Accessibility Survey

City of Downey Arnett Street - Downey Avenue to Mcgovern Avenue

Date of Inspection
6/13/2017

Disability Access Consultants

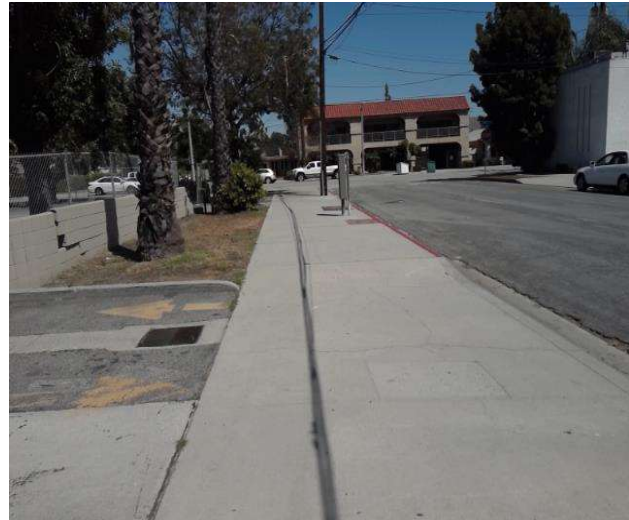
Cross slope at vehicular traffic is not compliant.

On-Site Finding 3.10 percent

Repave the surface to provide a compliant cross slope.

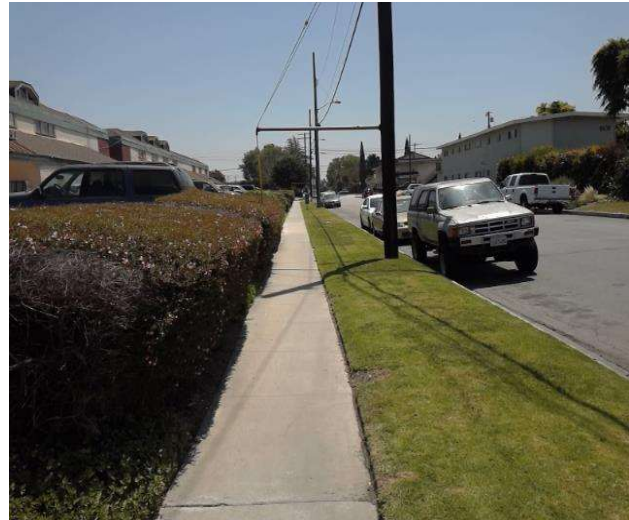
Sidewalk cross slope is not compliant.

On-Site Finding 4.20 percent for 100.00 feet

Repave the sidewalk surface with the recommended cross slope.

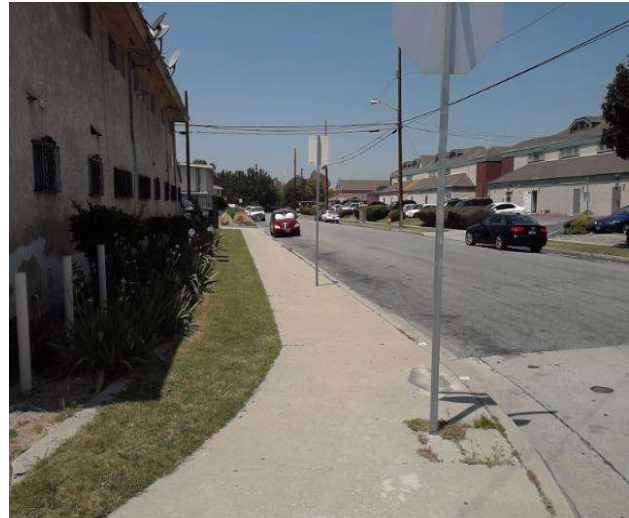
There is no 60X60 turn area at every 200 feet.

On-Site Finding Not Found

Provide a 60X60 turn every 200 feet on the sidewalk.

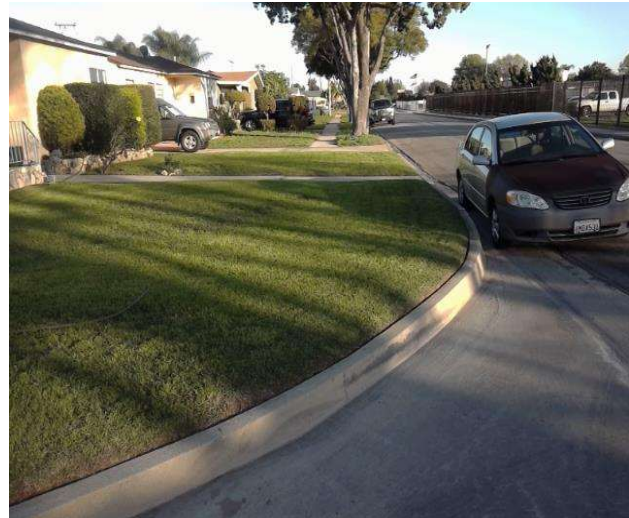
Section of sidewalk is missing and consists of dirt, grass or gravel.

On-Site Finding 46.00 feet

Provide a compliant sidewalk for the missing section.

Change In Level East Of Horton Avenue @ 33.943002811876, -118.145156800747

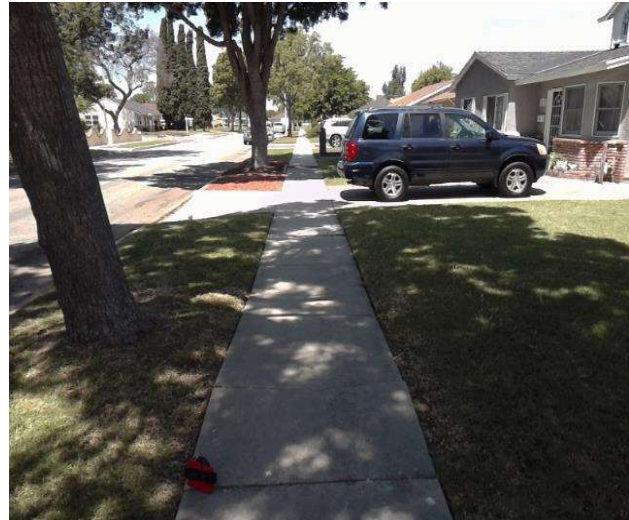
There is a change in elevation greater than recommended value.

On-Site Finding 0.50 inches

Ensure that the change in elevation is within the recommended value.

Change In Level East Of Horton Avenue @ 33.943027288445, -118.145214468241

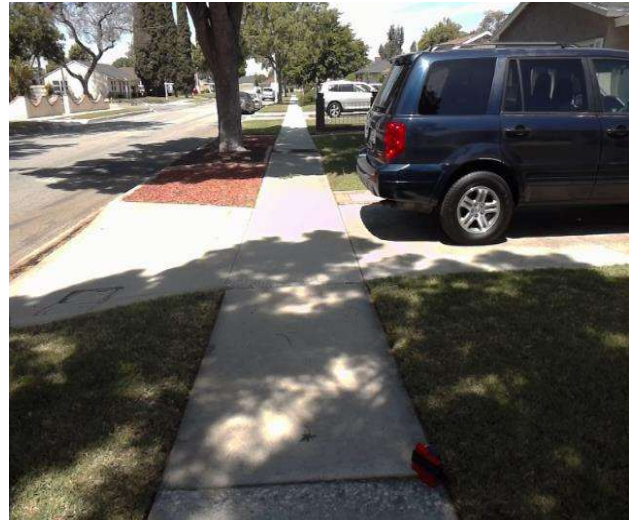
There is a change in elevation greater than recommended value.

On-Site Finding 0.62 inches

Ensure that the change in elevation is within the recommended value.

Change In Level West Of Horley Avenue @ 33.942974997583, -118.145420998335

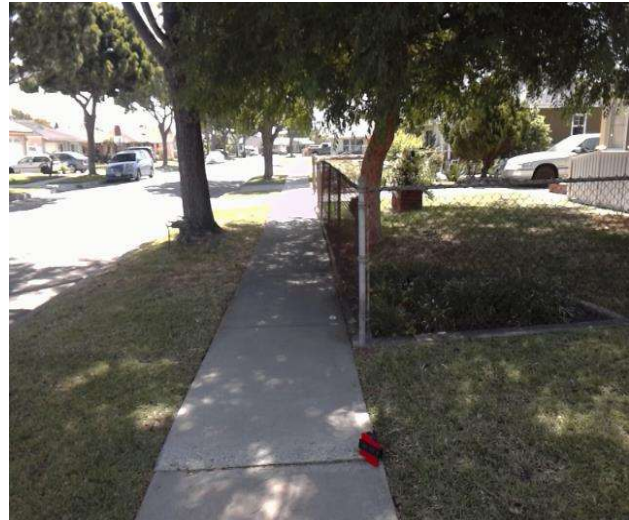
There is a change in elevation greater than recommended value.

On-Site Finding 0.75 inches

Ensure that the change in elevation is within the recommended value.

Change In Level West Of Horley Avenue @ 33.943012825018, -118.145474642515

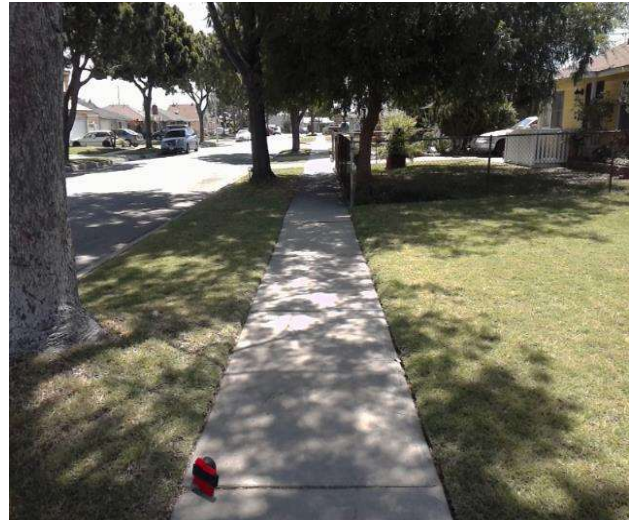
There is a change in elevation greater than recommended value.

On-Site Finding 0.50 inches

Ensure that the change in elevation is within the recommended value.
